Catherine Townend
National Highways
Your Reference: NHPR 22-12
By Email

30/07/2024

Proposed Construction of Motorway Service Area at South/Western Boundary Fronting M69, Land East of Stretton Croft, Wolvey Road, Leicestershire.

An excerpt of the site layout plan is shown below, which shows the current site layout plan (left) and the previous scheme at the site (right), which had no buffer and proposed a retaining wall adjacent to the highway boundary.

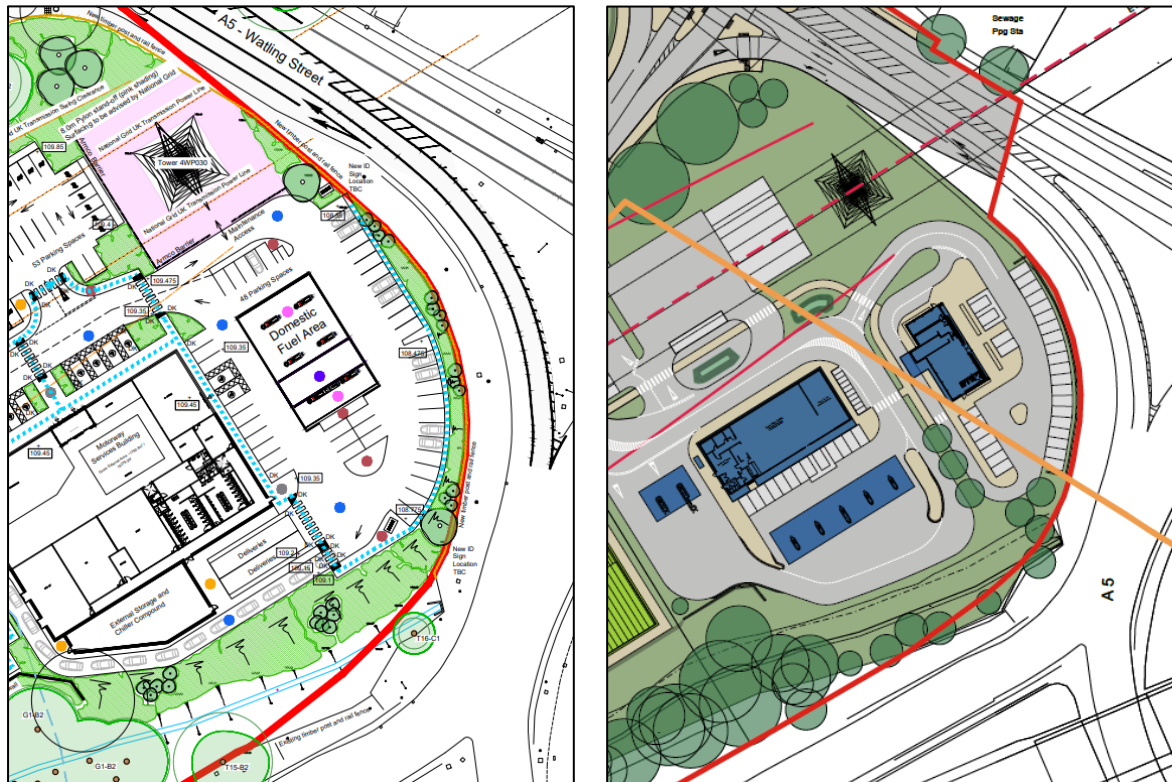
NH also state that, with regard to the ground impact the proposed development is unlikely to be acceptable as it would require a buffer zone between earth works and the public highway. The project architect has confirmed that the proposed site layout has designed out the need for a retaining wall, by providing a larger planted buffer zone between the proposed car park and the highway. This buffer zone will slope towards the highway as indicated by the slope ticks on the drawing. The gradient of the slope will be around 1in3, with the steepest change in levels occurring to the south of the bank of parking.
